STAFF RECOMMENDATION

1417 Russell Street

August 18, 2021

Application: New Construction-Infill; Violation/Show Cause

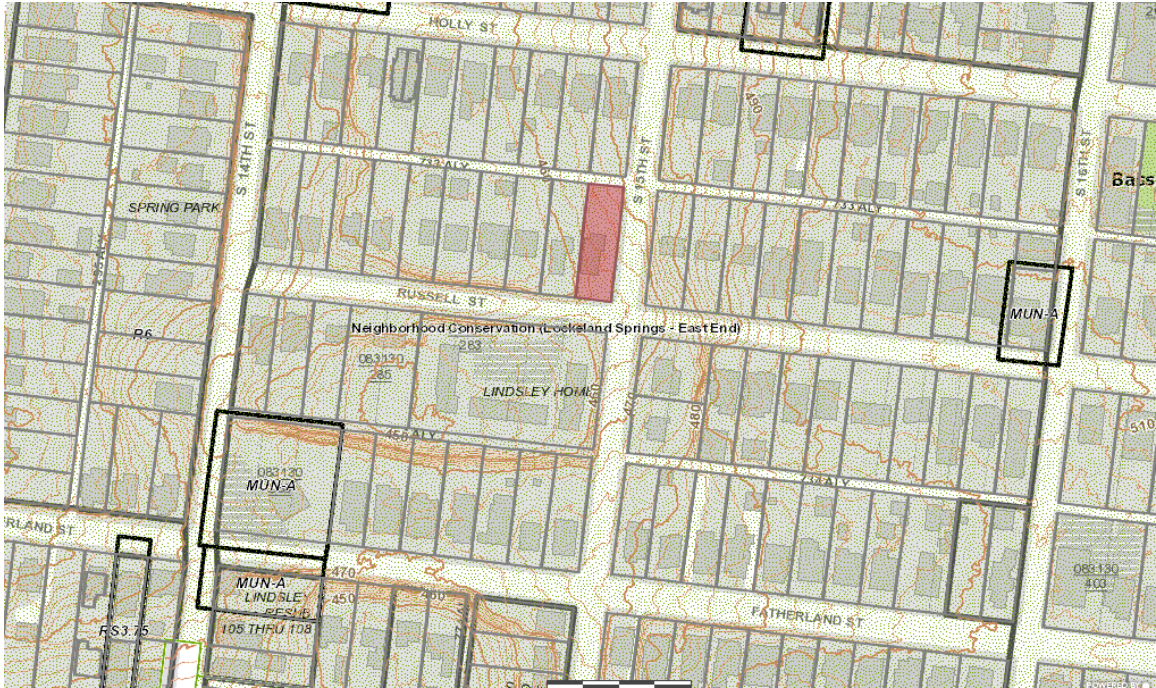
A site visit showed the front foundation as being significantly higher than what was approved in the permit. The applicant proposes building up the grade to the location shown on the additional plans submitted recently and to install a retaining wall on the southwest corner of the home. While some minor buildup of grading is common, this solution would result in the foundation and the overall height being too tall for the historic context. The project as-is and the proposed solution does not meet design guideline V(A)(1).

The applicant was advised to remove four rows of block but prefers to request the construction as-is. The applicant was told to cease work, at the time of the foundation inspection; however, they constructed some framing anyway. This framing will need to be removed in order to lower the height of the foundation.

Staff recommends disapproval of the foundation height as constructed and the proposed solution finding that the height and solution do not meet Section V(A)(1) of the guidelines for foundation height. Staff recommends that the foundation be lowered by at least four blocks within the next sixty (60) days.
